**New Albany Architectural Review Board Meeting Agenda**  
Monday, June 9, 2025 7:00 p.m.

**New Albany Architectural Review Board**  
Monday, May 12, 2025 Meeting Minutes - DRAFT

**Architectural Review Board Staff Report  
May 12, 2025 Meeting**

**CERTIFICATE OF APPROPRIATENESS  
6588 NEW ALBANY CONDIT ROAD**

#### **(2) Window Lettering**

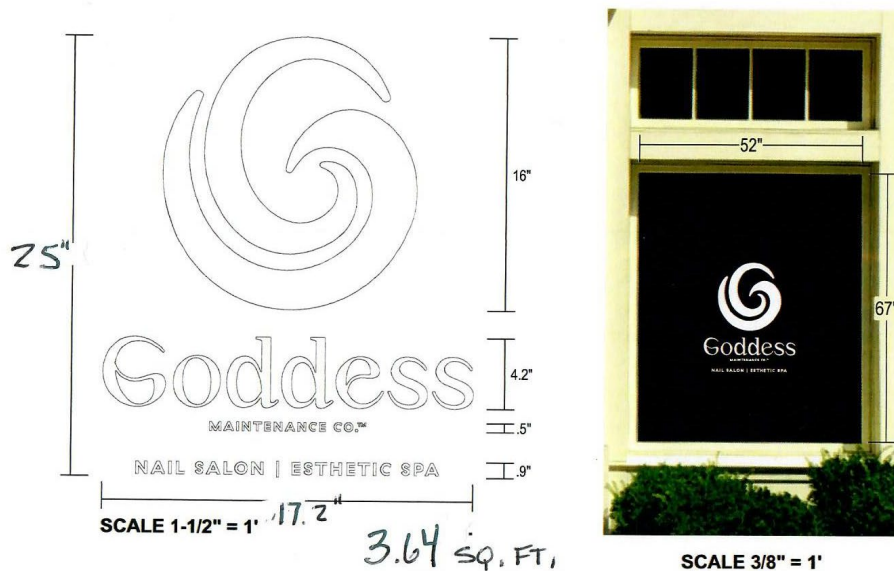
- e) Lighting: None [meets code].
  - f) Material: Vinyl [meets code].
  - g) Colors: White (total of one) [meets code].
- The proposed signs will read, "Goddess Maintenance Co. Nail Salon | Esthetic Spa" and will be centrally located in each window.

- The signs appear to be appropriately scaled given the storefront's window size.

### Goddess Maintenance Co. Wall Sign

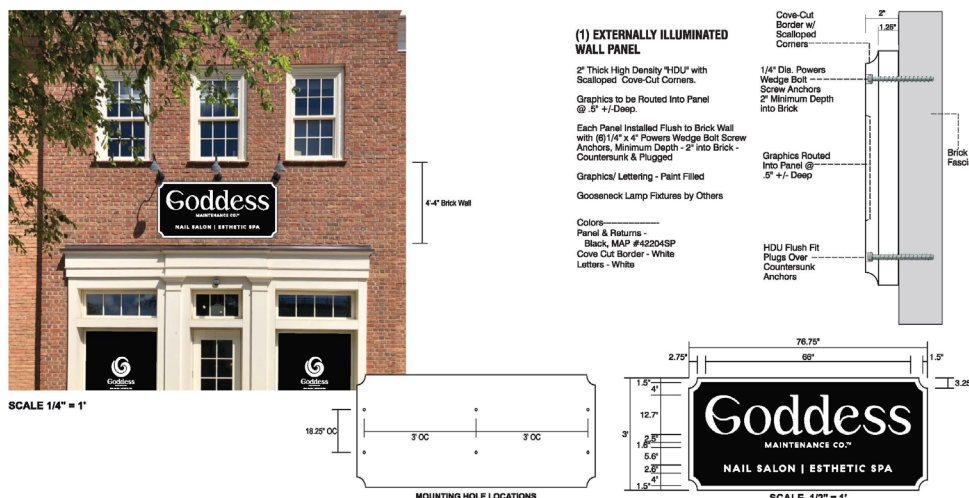
- City sign code Chapter 1169.16(d) permits wall signs with the following requirements: a maximum area of 40 square feet, one sign per business entrance, a maximum projection of 18 inches, a minimum sign relief of 1 inch, and a maximum lettering height of 24 inches. The applicant proposes one wall sign with the following dimensions:
  - a) Sign Area: 19.19 square feet [meets code].
  - b) Location: Proposed along W Main Street frontage [location meets code].
  - c) Lighting: Externally Illuminated Goose Neck Fixtures [meets code].
  - d) Lettering Height: 12.7" maximum [meets code].
  - e) Colors: White and Black (total of two) [meets code].
  - f) Sign Relief: 2" [meets code]
- The proposed signs will read "Goddess Maintenance Co. Nail Salon | Esthetic Spa" and be centrally located above the storefront entrance.

- The signs appear to be appropriately located on the building. Similar window signs have been previously approved by the Architecture Review Board in other locations in the Market Square area and are pedestrian-scaled and provide more visual interest along the Market and Main walkways. The proposed wall sign is located symmetrically to the storefront entrance and the existing gooseneck light fixtures.
